EVALUATION OF WATTS BAR UNITS 1 AND 2 CABLE PULLING AND CABLE BEND RADII CONCERNS

TER-C5506-649

Nuclear Regulatory Commission
Washington, D.C. 20555

January 30, 1987

Figure 1. One Phase of a 480-V Cable Indented by the Bus of a Different Phase in Cabinet 1-BD-212-A1-A (at intersection of arrows)

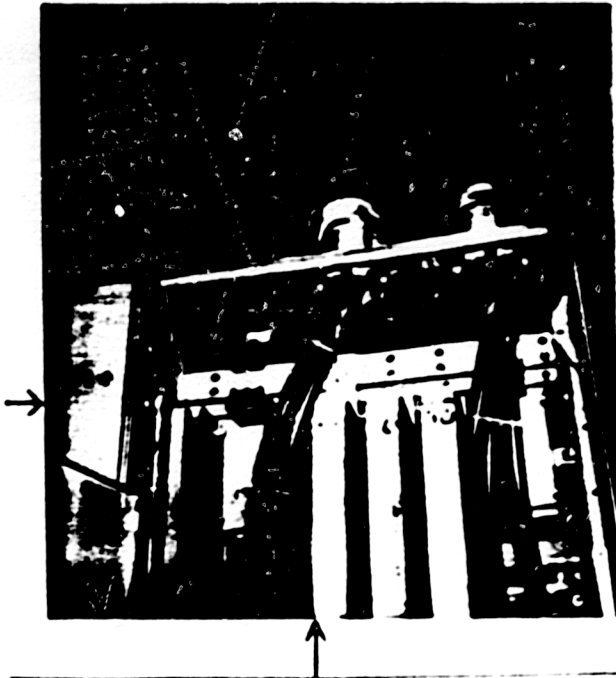
Inspection of the termination of the 480-V power cable from conduit 1PLC-2940A at Cabinet No. 1-BD-212-A1-A revealed a concern not relating to cable pulling or bend radius. The cable from one phase was firmly against a different phase of the bare bus. A potential for an eventual phase-to-phase fault exists. Figure 1 is a picture of this configuration.
